TECHNICAL SERVICE BULLETIN

Rubbing Noise At Front Of Vehicle While Driving And/Or DTCs C0031 And/Or C0034 - Built On Or Before 14-Jun-2021

22-2118

Ford 2021 F-150	Built on or before 14-June-2021
---------------------------	---------------------------------

Figure 1 - Correct routing

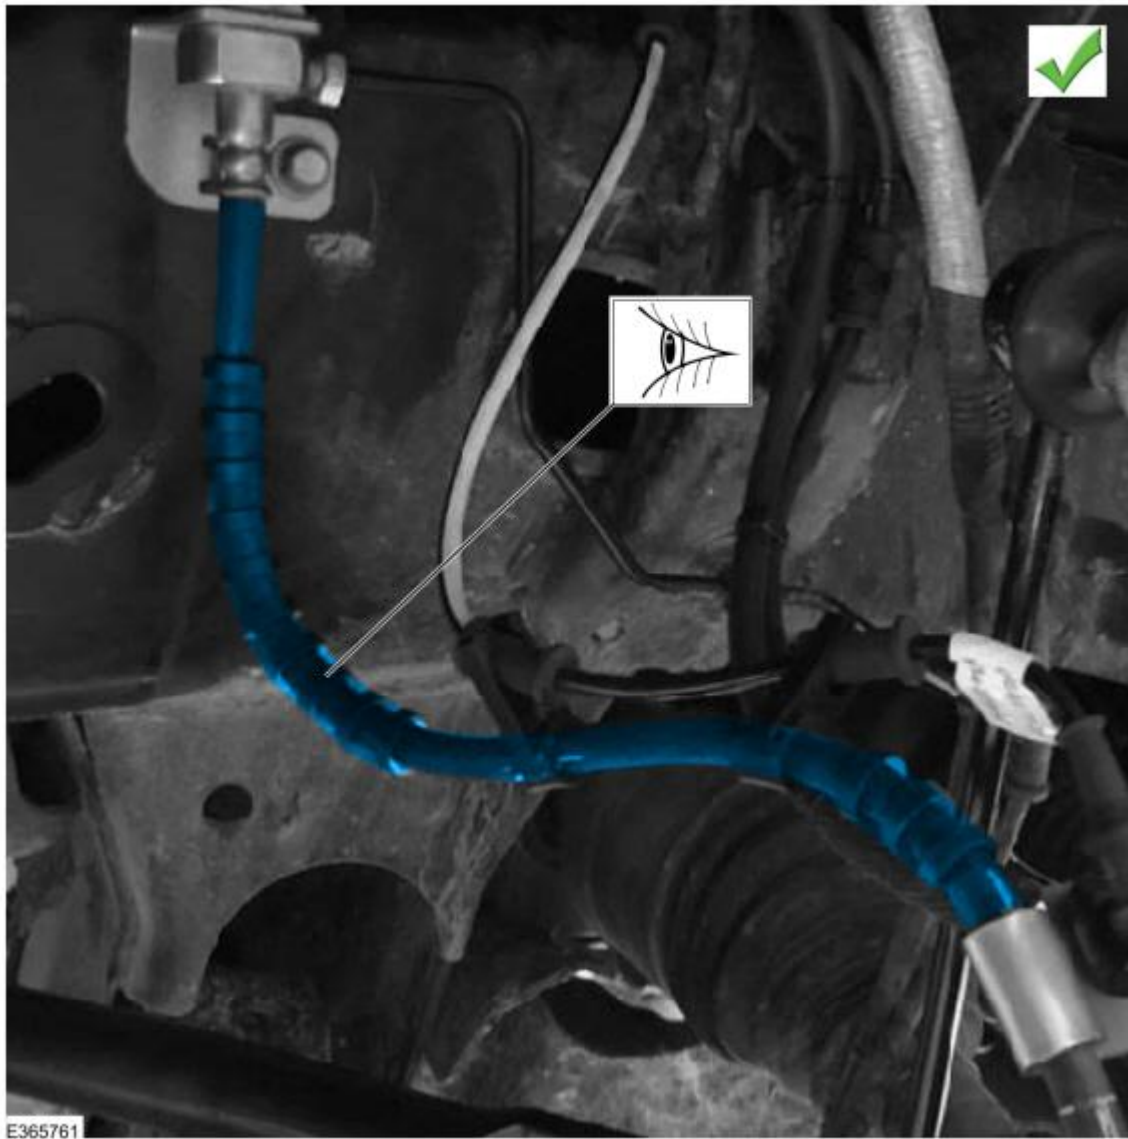
1. With the vehicle on the ground or a drive-on hoist and the steering wheel centered, inspect the routing of both front brake flexible hoses. (Figures 1-2)

NOTE: The flexible hoses must travel downward on the frame side before bending and bend near where they enter the bracket secured to the steering knuckle. There should be greater than 3/4 inch (19 mm) clearance between the brake flexible hose and the wheel/tire assembly.

2. Are both front brake flexible hoses routed correctly? (Figure 1)
 - (1). Yes - this article does not apply.
 - (2). No - proceed to step 3.
3. Replace the affected front brake flexible hose(s). Refer to Workshop Manual (WSM), Section 206-03. When installing the new hose(s), they must travel downward on the frame side before bending toward the steering knuckle and then bend near the bracket secured to the steering knuckle. (Figure 1)
4. Inspect the affected wheel speed sensor harness(es). Is the wheel speed sensor harness damaged?
 - (1). Yes - replace the affected wheel speed sensor.
 - (2). No - repair is complete.
